Nomad SERVICE BULLETIN

SERVICE BULLETIN NO: NMD-28-12

TITLE: Fuel - Introduction of Dual Commutator
Fuel Boost Pumps (Modification N313)

REVISION NO: 1

MODIFIED SUMP LID ASSEMBLY
Figure 1

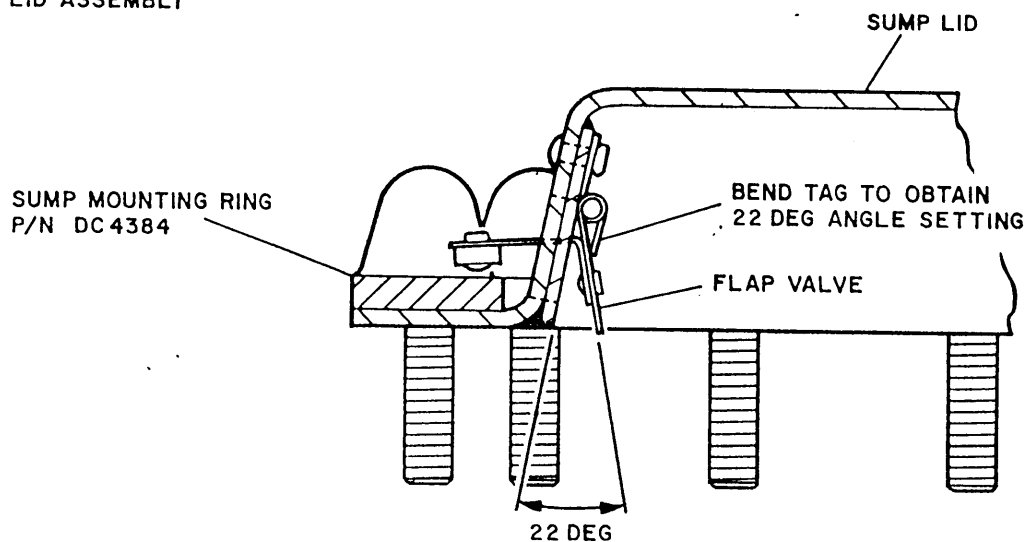
Assemble the flap valves to the modified sump lid P/N 1/N-57-348 using rivets P/N MS20470A3-5. Set the flap valves tag to obtain the angle shown in Figure 1. Re-identify the sump lid assembly by marking the new part number 1/N-57-349 in ink at the position shown in Figure 1.

NOTE: FLAP VALVE
INSTALLATION SIMILAR
AT FWD END OF SUMP
LID ASSEMBLY
